**AGENDA  
FOR THE CITY OF OLIVETTE  
PLANNING AND COMMUNITY DESIGN  
COMMISSION  
MEETING OF AUGUST 4, 2016  
AT 7:00 P.M.  
IN THE OLIVETTE CITY COUNCIL  
CHAMBERS  
AT CITY HALL GOVERNMENT CENTER  
LOCATED AT 9473 OLIVE BOULEVARD**

**A. 724 Mansfield Drive**

Description: New Single Family Home

**DATE:** JUNE 16, 2016  
**TO:** PLANNING AND COMMUNITY DESIGN COMMISSION  
**FROM:** CARLOS TREJO, AICP  
DIRECTOR OF PLANNING AND COMMUNITY DEVELOPMENT  
**RE:** 724 MANSFIELD DRIVE  
PETITION FOR COMMUNITY DESIGN REVIEW & CONCEPT STORMWATER MANANGEMENT  
PLAN REVIEW

**RIGHT ELEVATION**  
VERIFY ALL DIMENSIONS AND CONDITIONS IN THE FIELD.

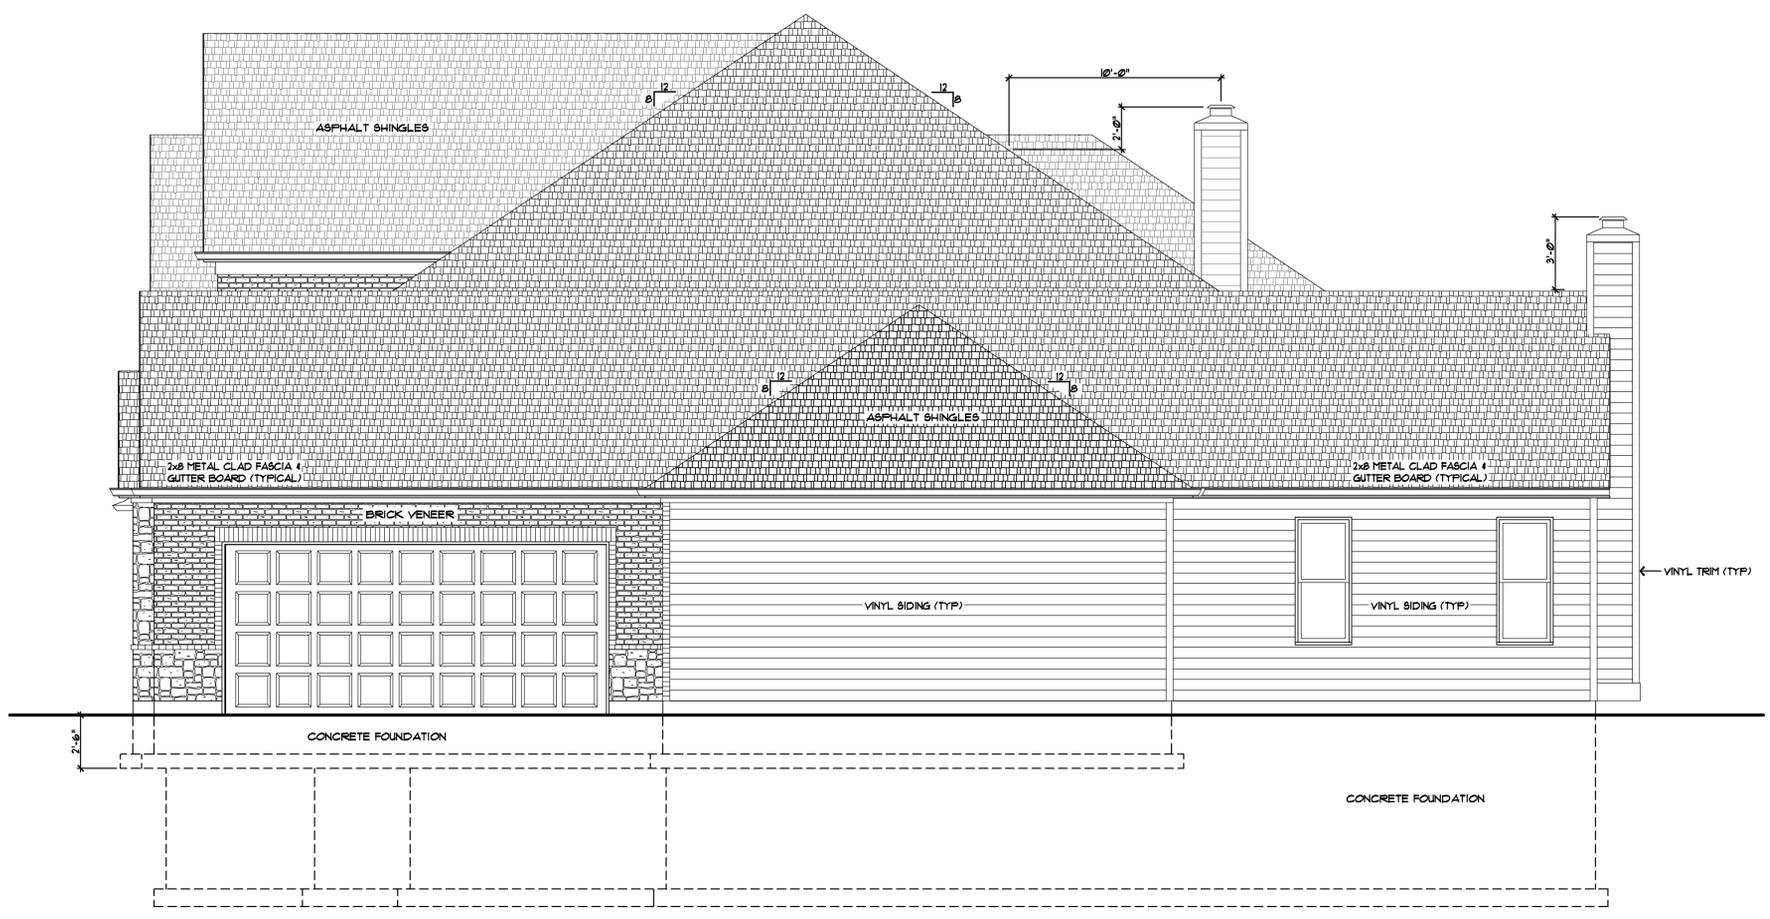
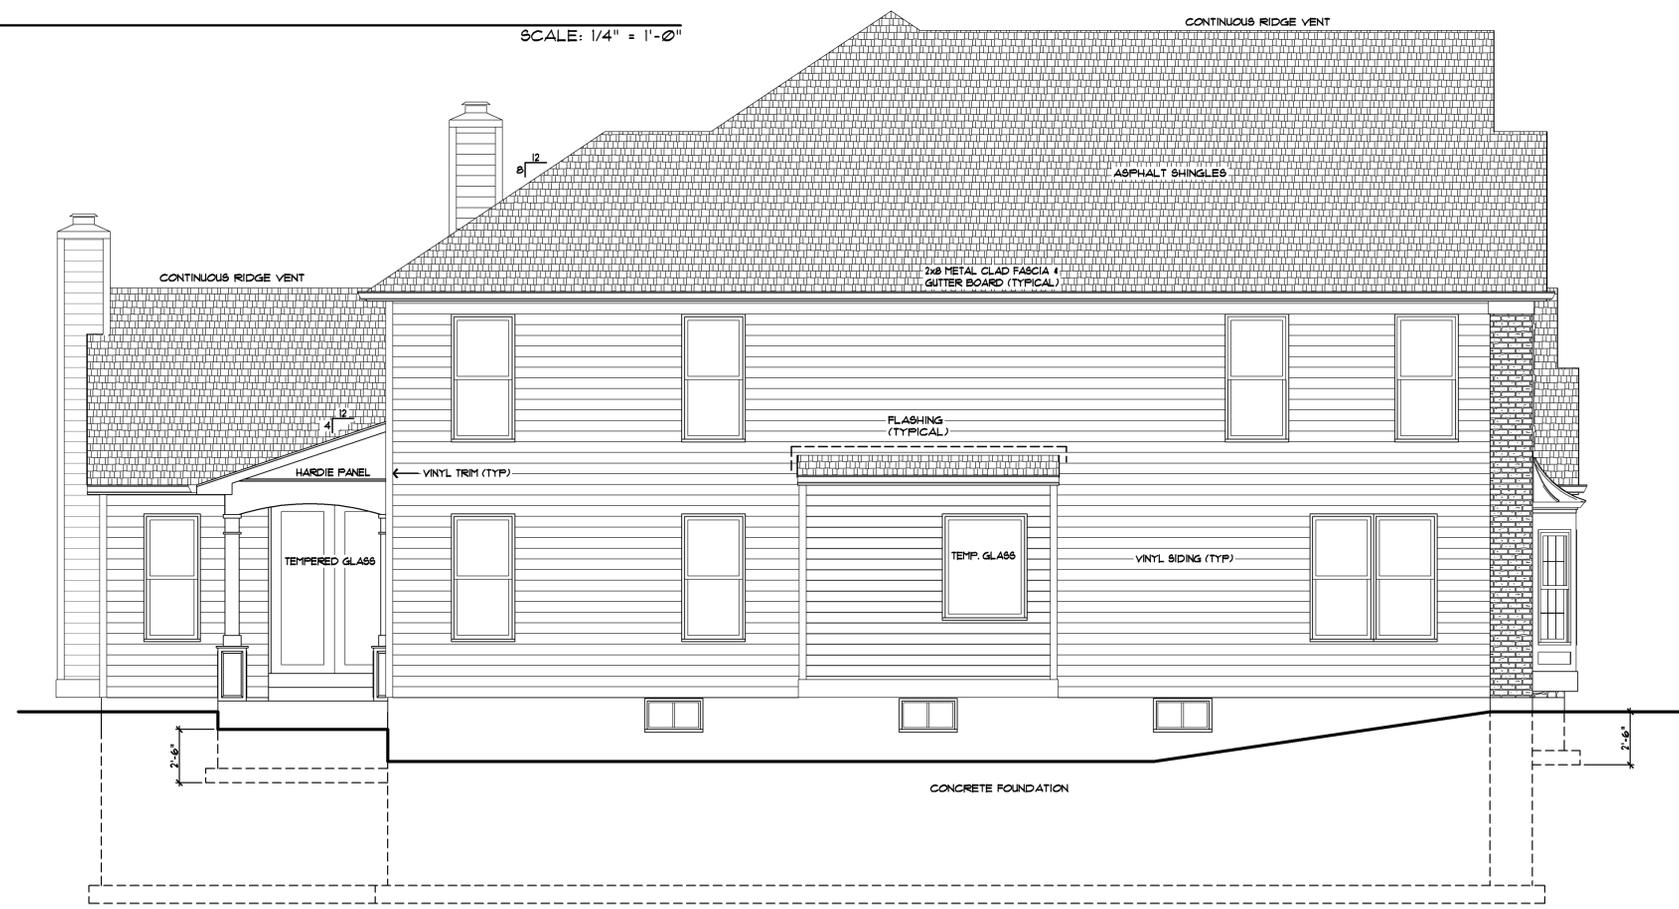
The amount of foundation exposure cannot exceed 12-inches above the grade. The rear and left elevations both need to be revised to lower the exposure to 12-inches or less.

4. Any exposed portions of the foundation wall along Mansfield Drive and the site elevation along the north and south in which the foundation wall exceeds a height of one foot (1') above the approve finished grade shall have an exterior finish cover equal to that of the overall exterior elevation finish. Building plans submitted at the time of building permit application are to be reflective of this condition.

# SITE PLAN

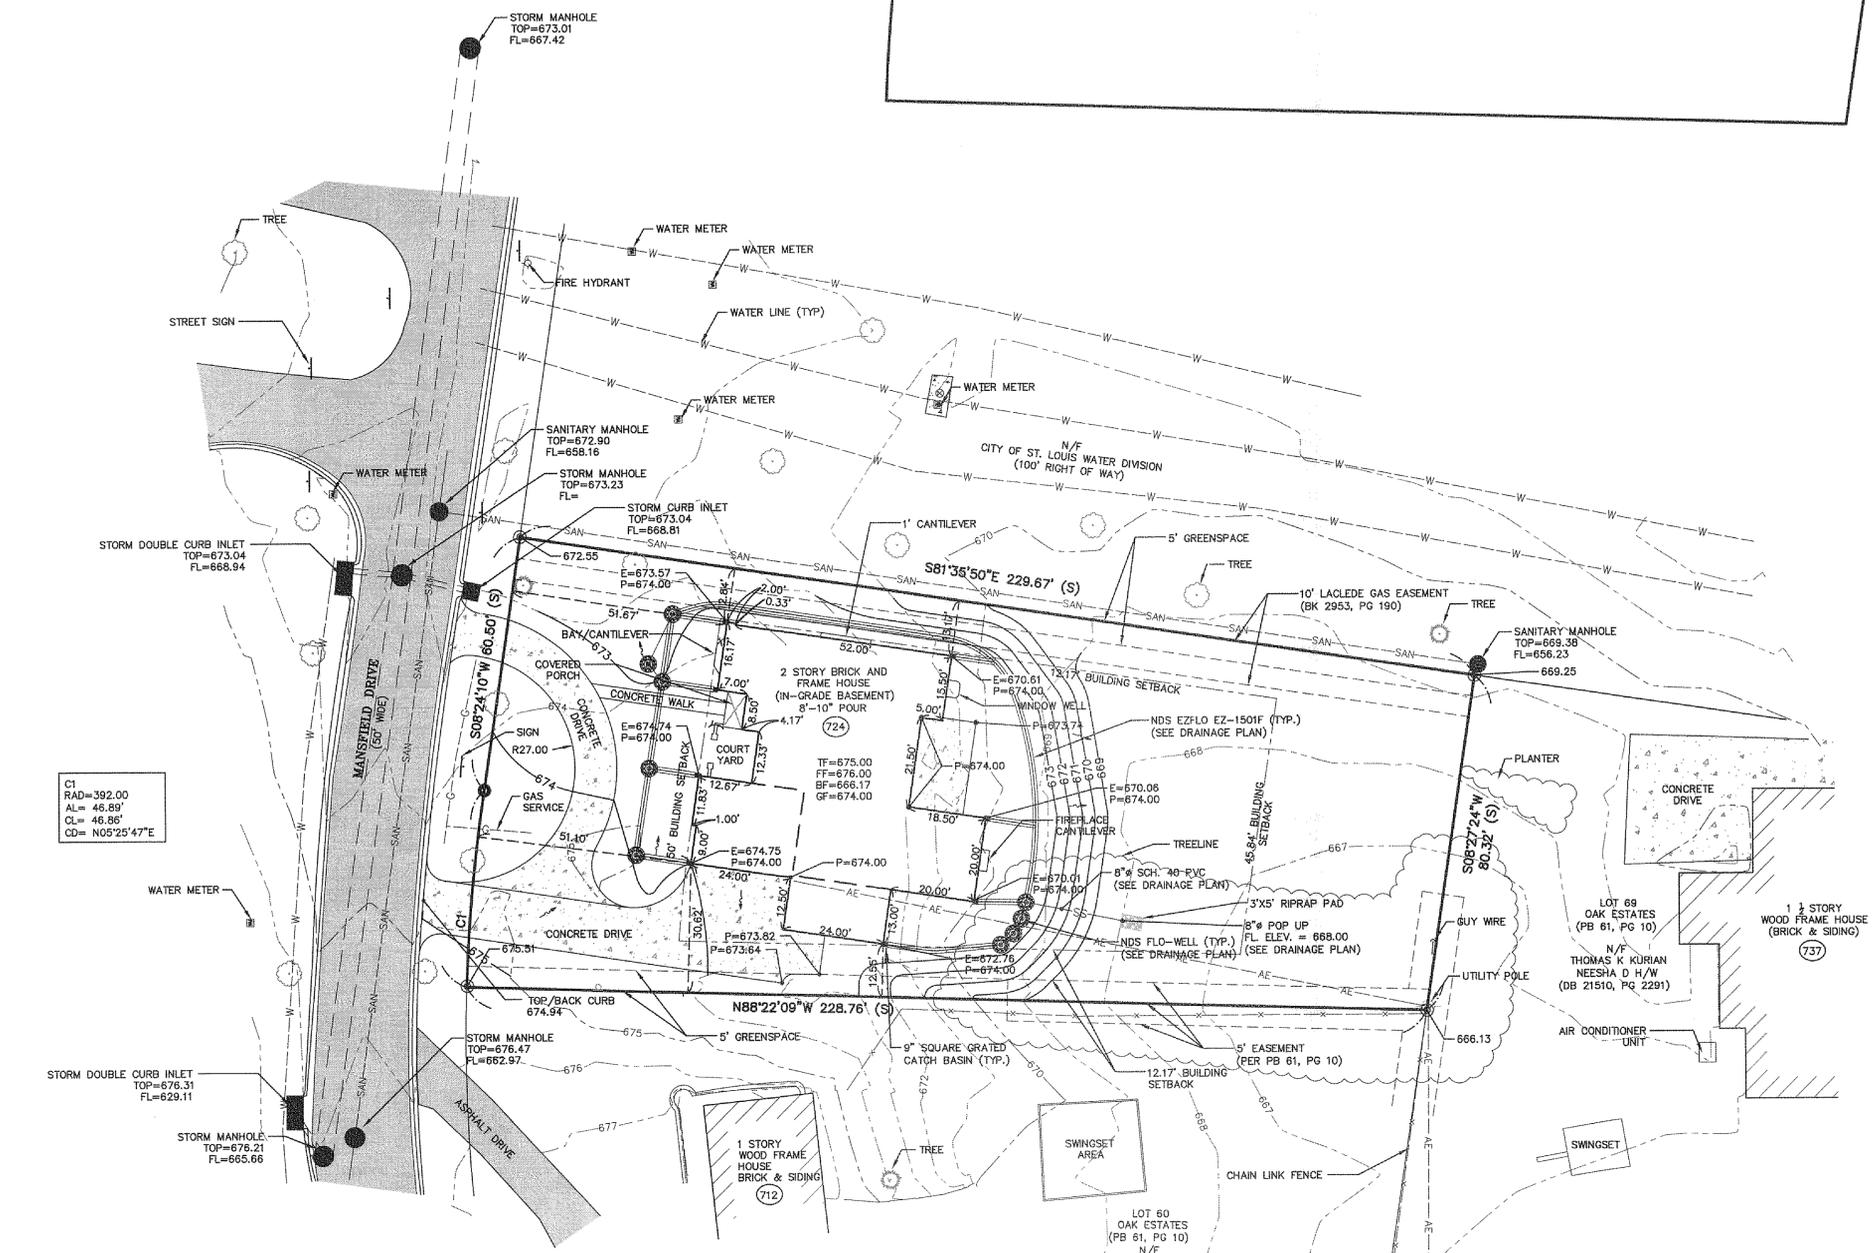
1. Petition for a two level home with 2-car side-entry garage and 1-car recessed front entry garage.
2. Zoning: The proposed plans do not comply with the Minimum Standards For Off-Street Parking Areas of Article XIV Off-Street Parking and Loading.

The plans received on June 23, 2016, illustrate a two-car side entry garage and a recessed one-car front entry garage. The proposed site plan fails to conform to Article XIV Off Street Parking and Loading of Chapter 400 Zoning Regulations, specifically Section 400.1410 Minimum Standards for Off-Street Parking Areas. The proposed site plan notes the turnaround pad to be 2.6-feet from the side property line to the south, which has been found non-compliant with the following Section 400.1410.A.2.b.1

The proposed site plan fails to conform to Article XIV Off Street Parking and Loading of Chapter 400 Zoning Regulations, specifically Section 400.1410 Minimum Standards for Off-Street Parking Areas. Staff measured the turnaround pad to be 2.6-feet from the side property line to the south, which has been found non-compliant with the following Section 400.1410.A.2.b.1

1. The top of foundation elevation be limited to no more than 675.00. As noted above, a revised site plan shall be submitted illustrating approved grading. Staff shall be provided an opportunity to require additional grading changes to the site, including adjusting the proposed top of foundation, as necessary to control/limit stormwater runoff on the site and to adjacent properties.
